November 28, 2011

RE: MAHONING COUNTY
YOUNGSTOWN IRON & METAL, INC.
NPDES PERMIT NO. OHR000004
OHIO EPA PERMIT NO. 3GR00727*DG
INDUSTRIAL STORM WATER INSPECTION

NOTICE OF VIOLATION

Figure 10 - A spill of transmission fluid within has a "storm pit" that discharges to "waters of the State." Picture taken November 16, 2011.

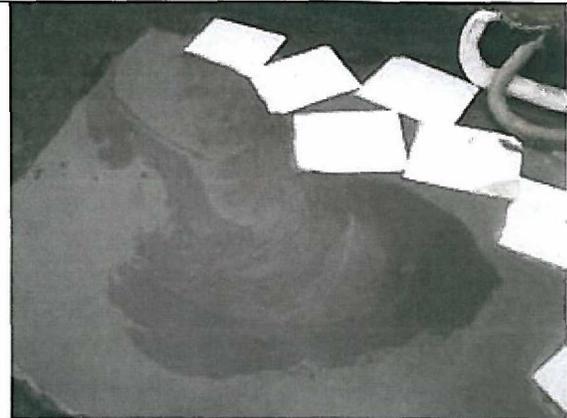
The implementation of spill prevention and response procedures continues to require significant improvement throughout the facility. Ohio EPA documented oil spills and leaks associated with the "mobile maintenance area" (Figures 1 to 4), oil saturated soils and gravel materials throughout the facility (Figures 2, 4, and 5 to 6), an uncovered dumpster leaking oil resulting from the disposal of oil saturated booms and absorbent pads (Figure 7), a sheer engine leaking oil (Figure 8), the acceptance of scrap materials leaking fluids (Figure 9), a spill of transmission fluid within a "storm pit" (Figure 10), and storm water runoff containing oil sheens throughout the facility (Figures 11 to 14).

- The control of oil being discharged via storm water runoff continues to require significant improvement throughout the facility. Oil and transmission fluid were being discharged into the storm sewer system serving the facility in numerous locations (Figures 10 to 14). Although large quantities of booms and absorbent mats have been utilized in numerous locations within the storm sewer system, monitoring data provided by the facility via a letter of response dated November 16, 2011, reported that the effluent being discharged on October 3, 2011, had an oil and grease concentration of 26.4 mg/L. No sampling data appears to have been collected from "Discharge #2."

- Since the clogged storm sewer line has been repaired, the facility must move forward on installing the oil and water separators necessary to address the continuing discharges of oil and grease into the facility's storm sewer system and "waters of the State."

Figure 16 - Secondary containment is not provided around fifty-five gallon drums where fluids are extracted. Picture taken October 31, 2011.

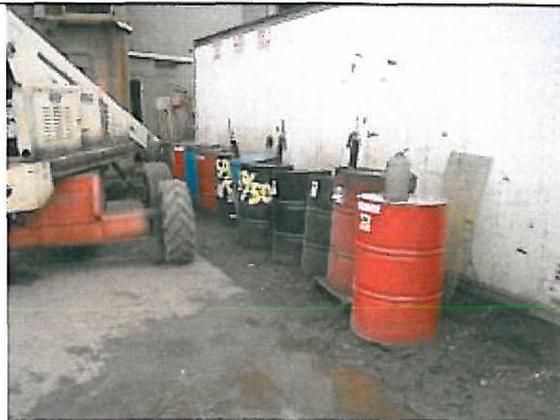
Fifty-five gallon drums where liquids are transferred to or extracted from are stored in locations exposed to precipitation events do not have secondary containment to prevent discharges of pollutants “waters of the State.” Mr. Grimes stated that he was aware of the lack of secondary containment. A work order had not been generated through Maintenance Connection to address the deficiency.

- Secondary containment must be implemented on all fifty-five gallon drums and ground level and above ground storage tanks where liquids are transferred to or extracted from

in storage locations exposed to precipitation events. The facility must submit a compliance schedule that includes the date(s) when secondary containment will be implemented.
